R0015381 Upgrade Secondary Transfer Table Sensors

Adding a secondary ultrasonic sensor to the 7 transfer loading positions to backup the flaps

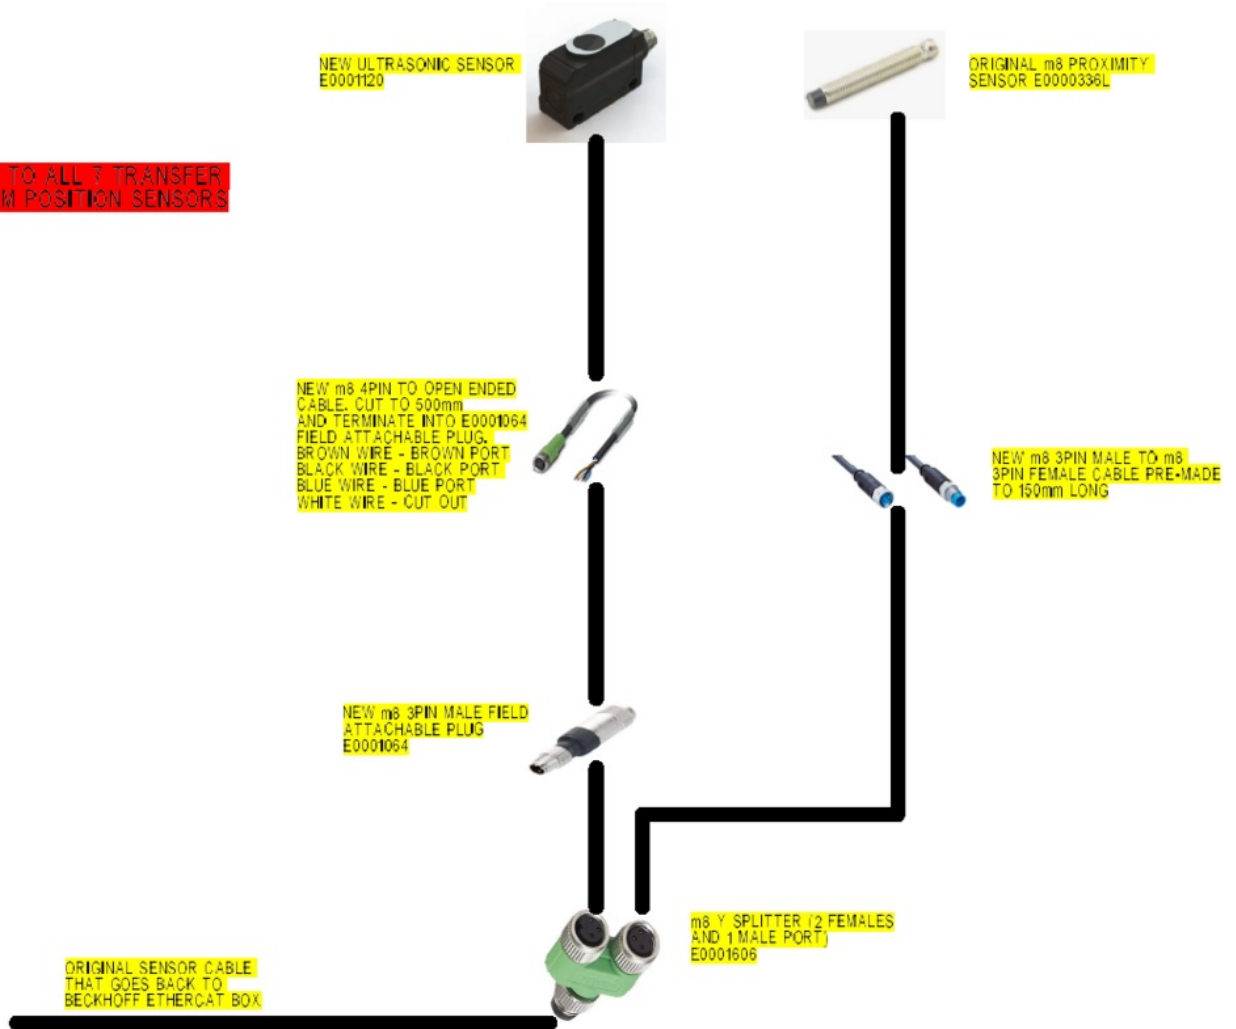
If bars are bowed at one end, the transfer table flaps may not depress enough to activate the sensor. The sensor is limited to 4mm in its sensing range

A simple-fit system has been designed to provide a secondary backup to the flap using an ultrasonic sensor and an M8 Tee Splitter. This is a plug and play solution that does not require any reprogramming or additional IO channels.
